Date: November 30, 2023
To: All Vendors
Subject: Addendum #2

**REFERENCE: B014-24 Re-Bid BPUB Downtown Wastewater Improvements-ARPA
Project 1**

Project:	Brownsville PUB – Downtown Wastewater Improvements ARPA Project 1 BPUB Bid No. B014-24	Addendum Date:	November 30, 2023
From:	Javier A. Esquivel, PE	Project No.:	BPUB2200025.01

ADDENDUM No. 2

SHEET
CC04

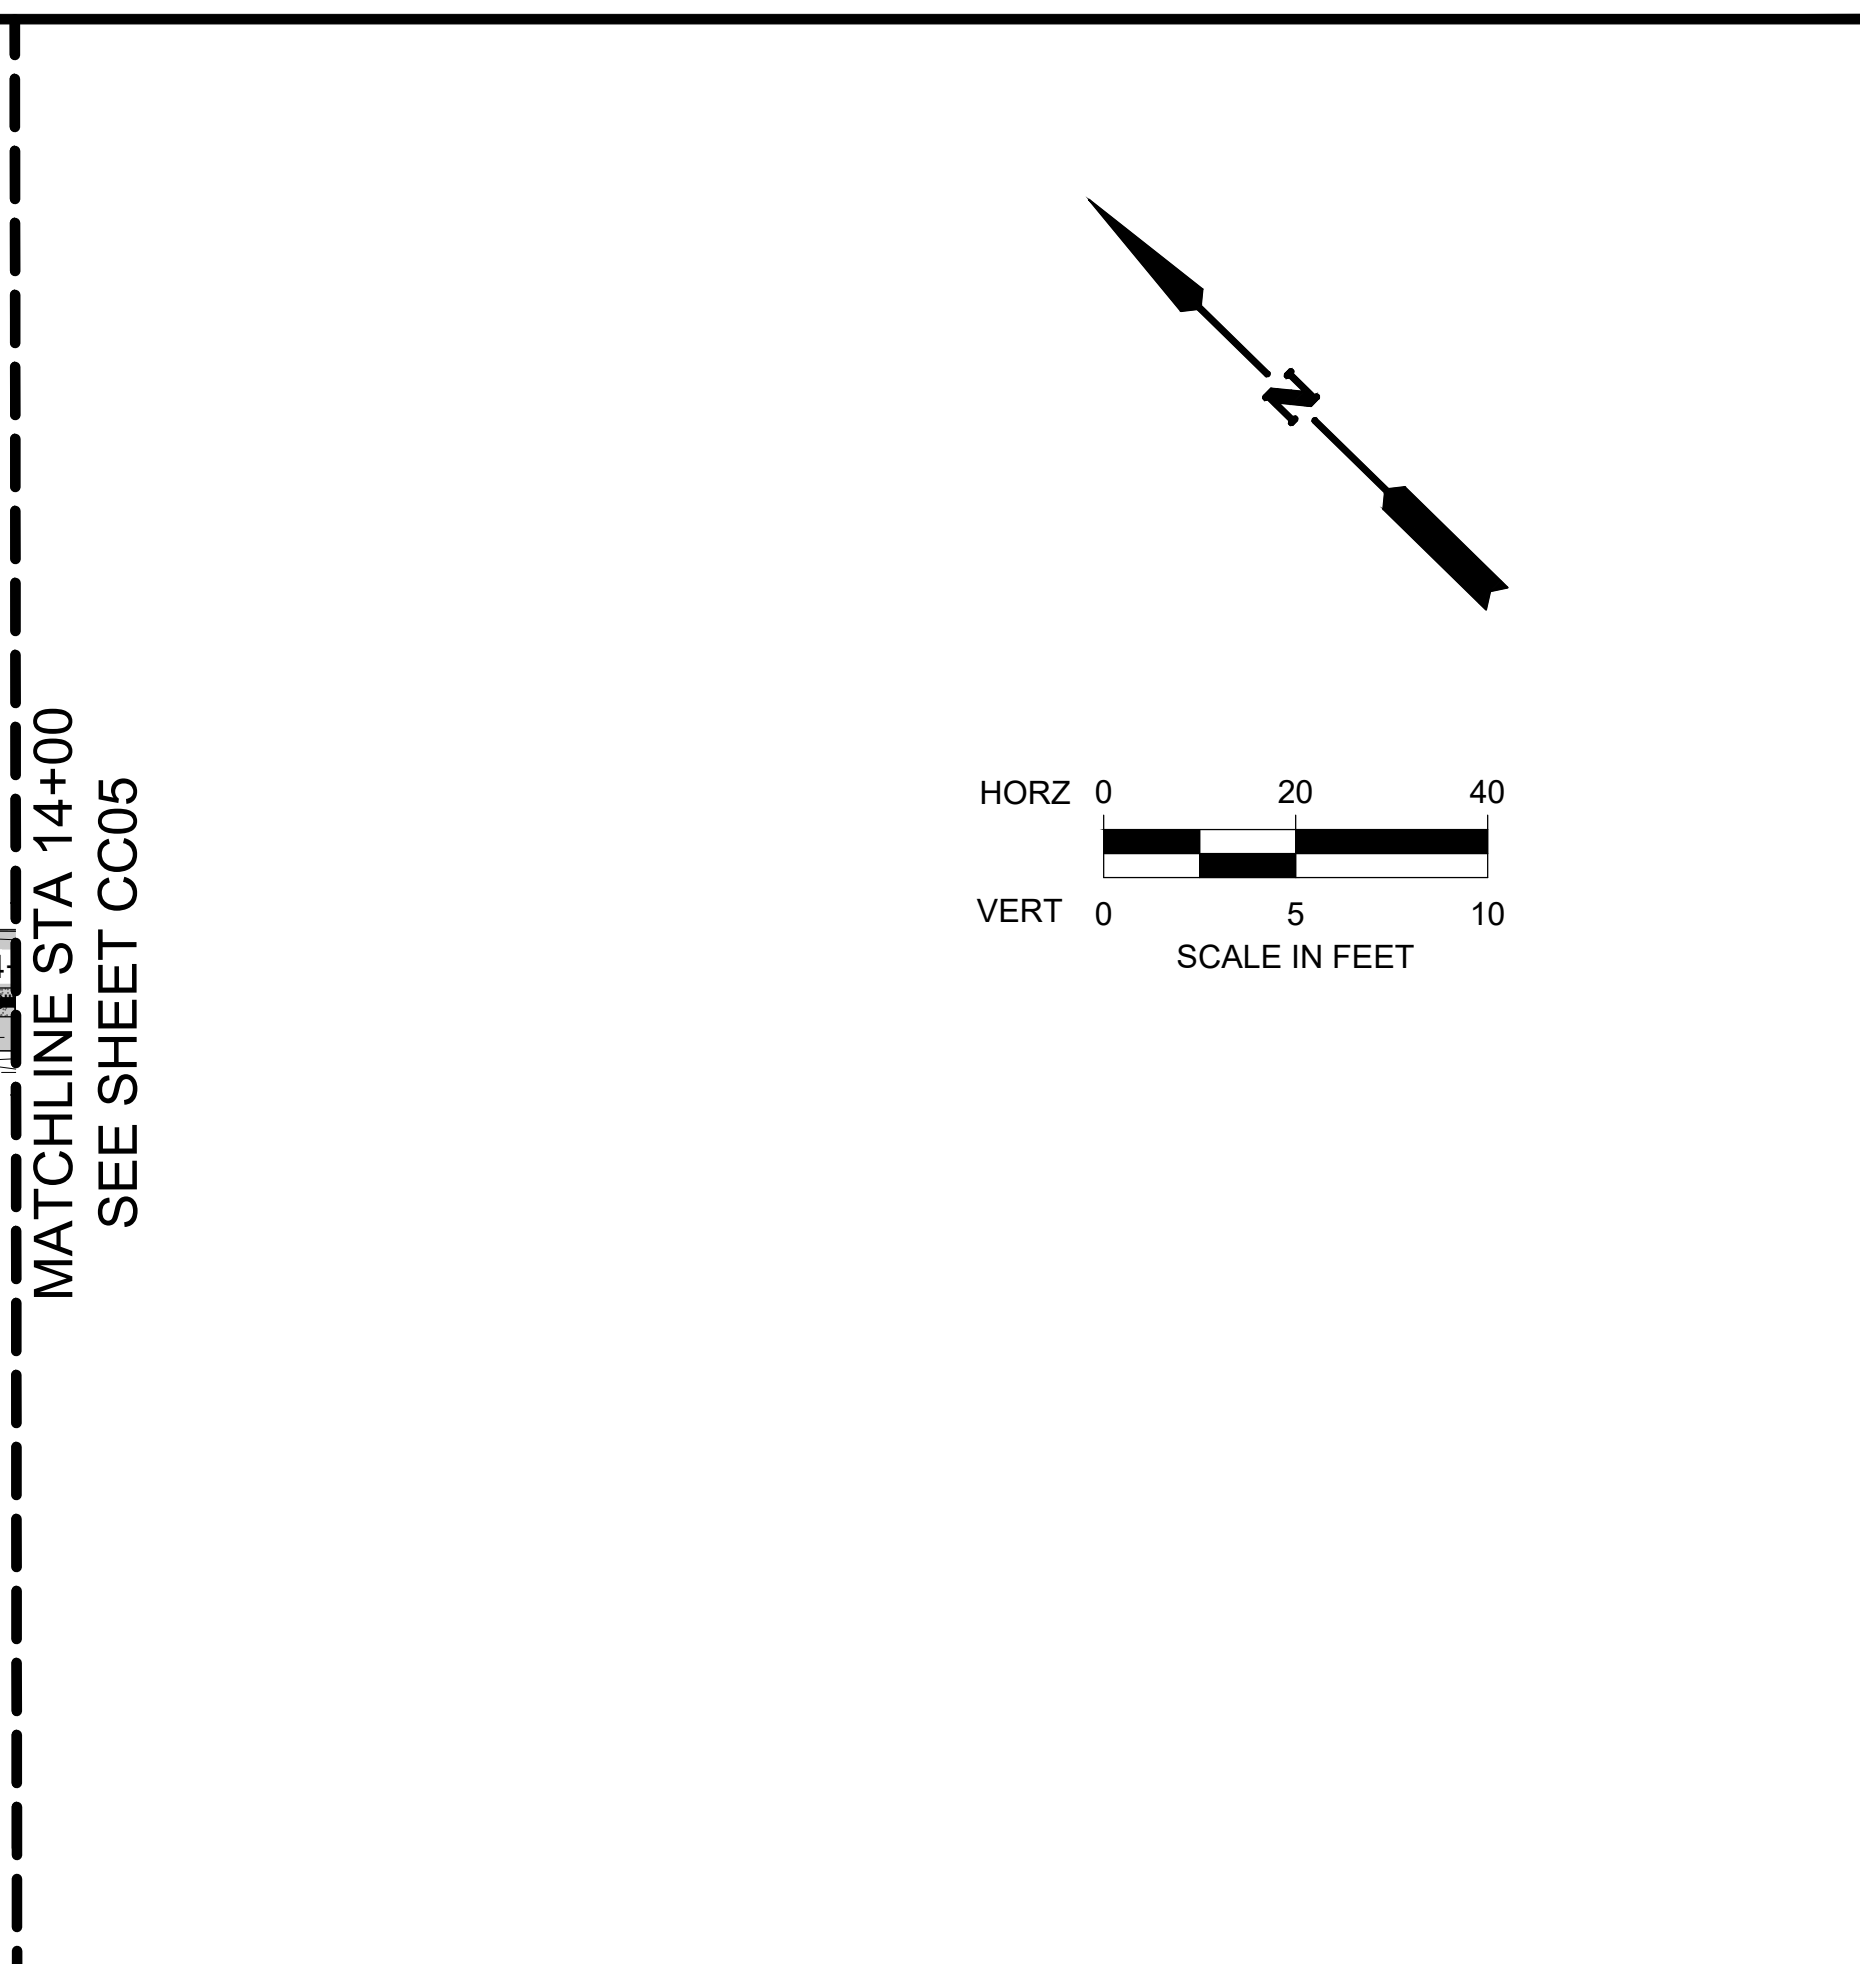
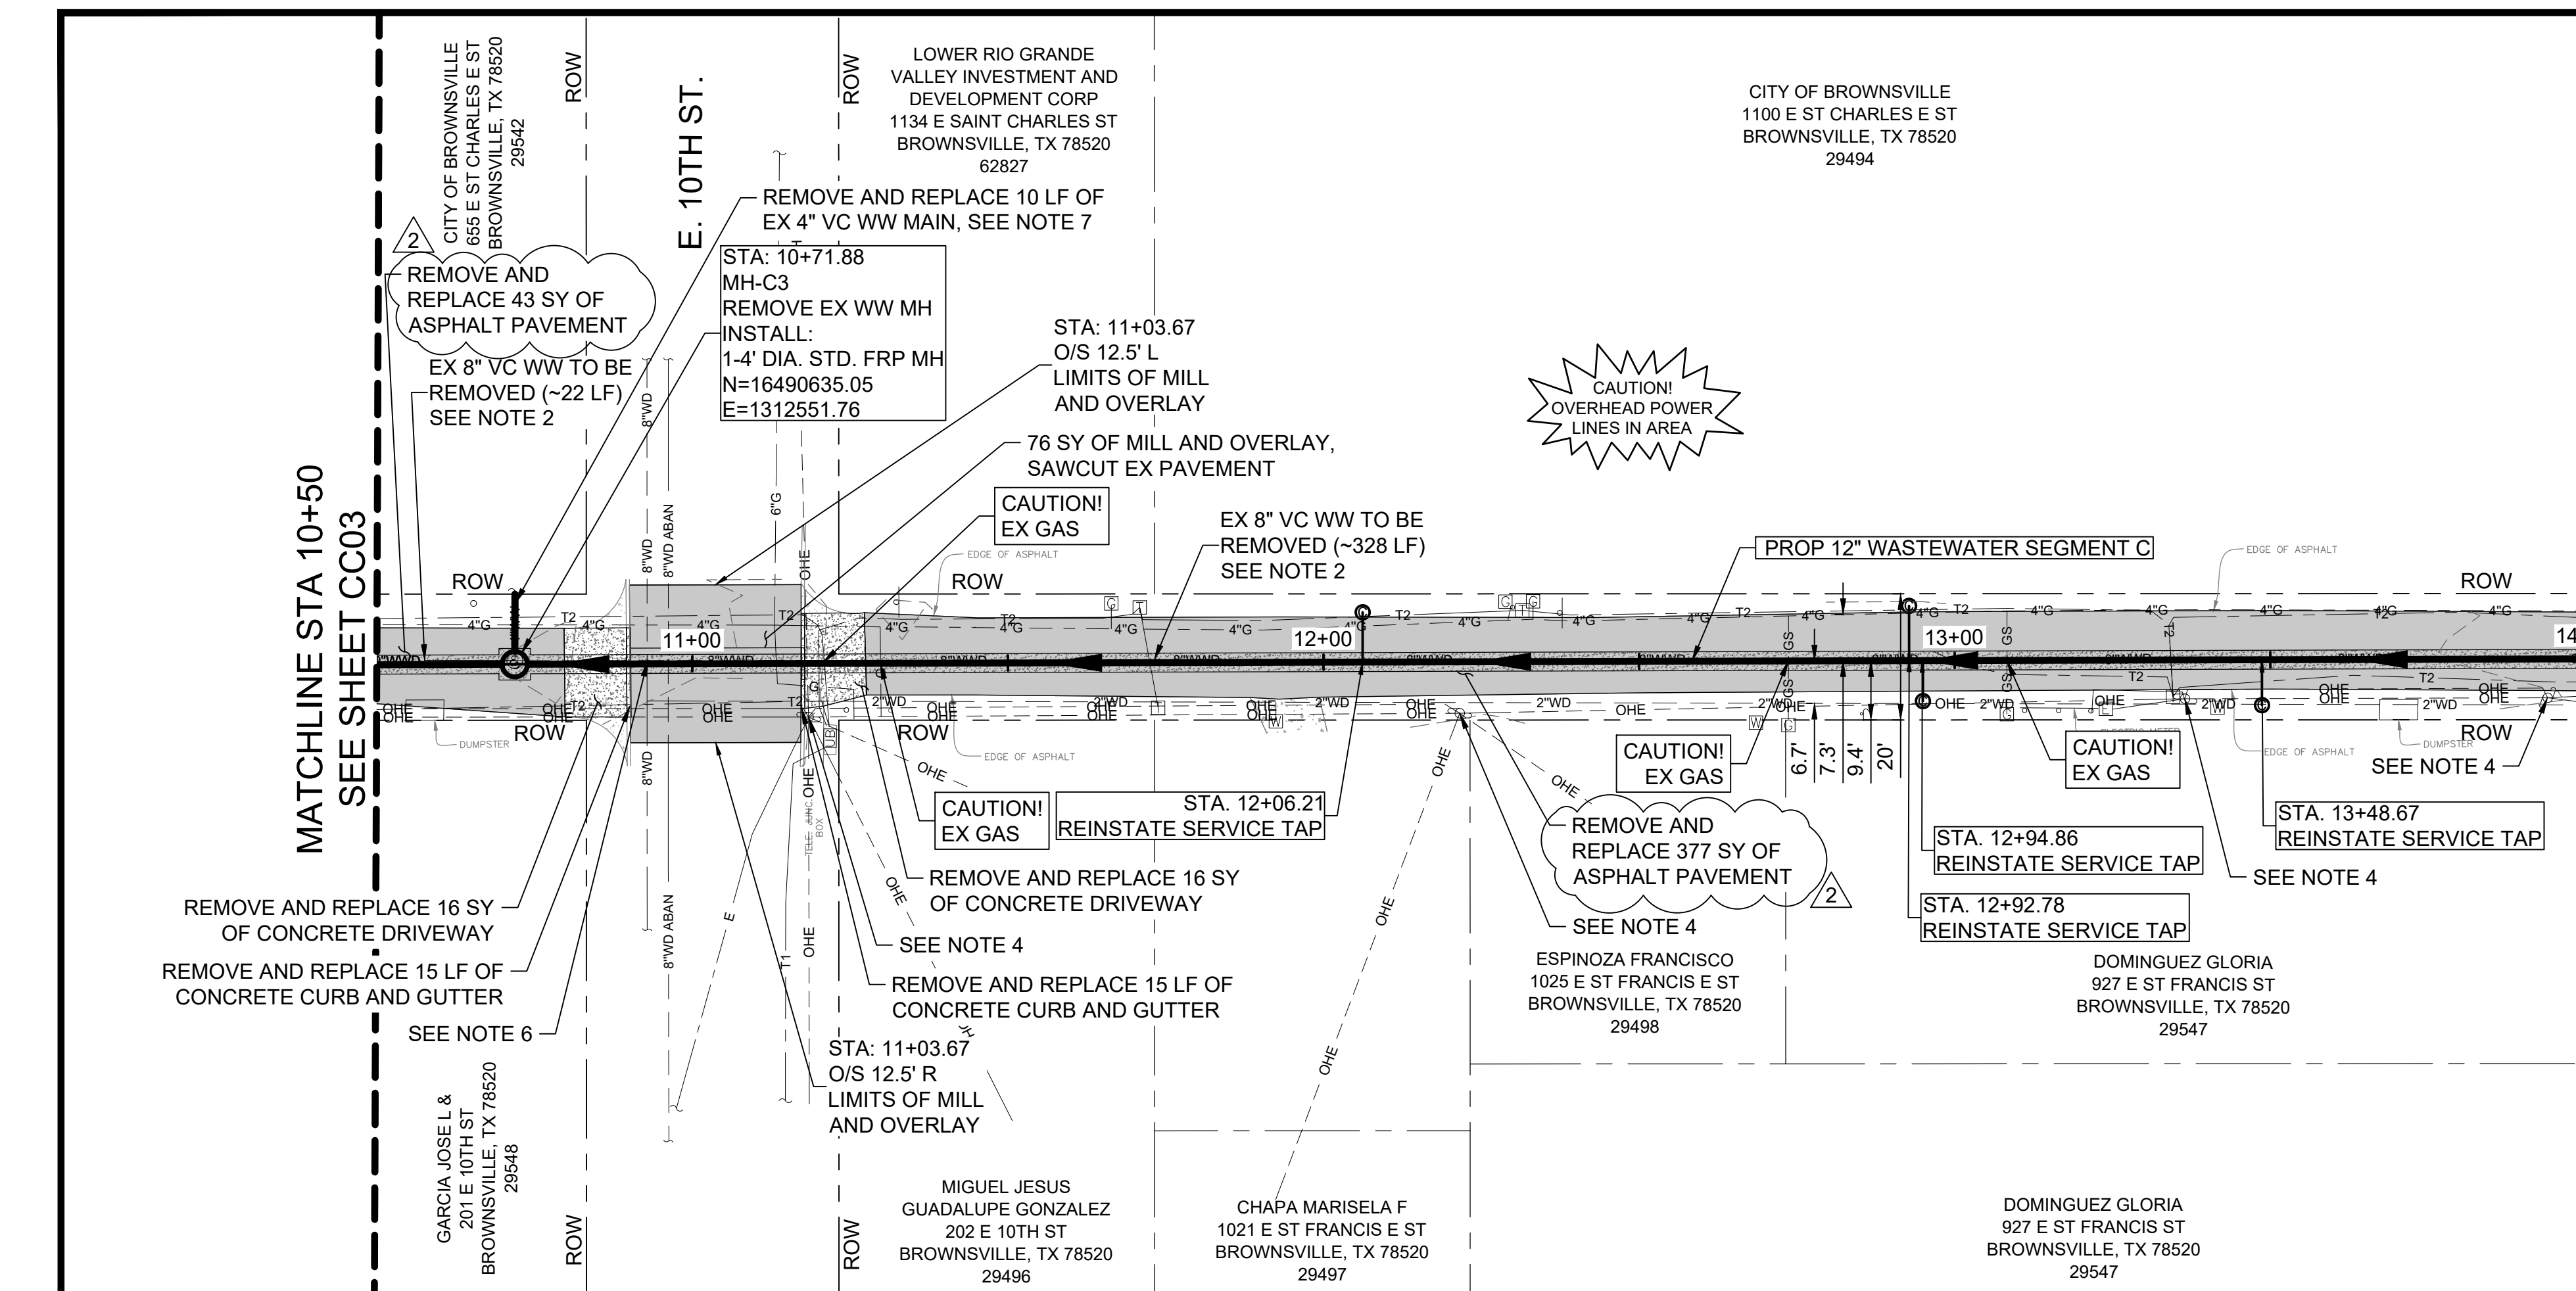
1. Revisions to Surface Restoration in the Alleys.
 - Segment A: Replace Mill and Overlay (2”) with full depth concrete asphalt pavement removal and replacement.
 - Segment B: Replace Mill and Overlay (2”) with full depth asphalt pavement removal and replacement.
 - Segment C: Replace Mill and Overlay (2”) with full depth asphalt pavement removal and replacement.

3. Plan Sheets: The following plan sheets were modified to update surface restorations CA02, CA03, CA04, CA05, CA06, CA07, CB01, CB02, CB03, CC02, CC03, CC04, and CC05.
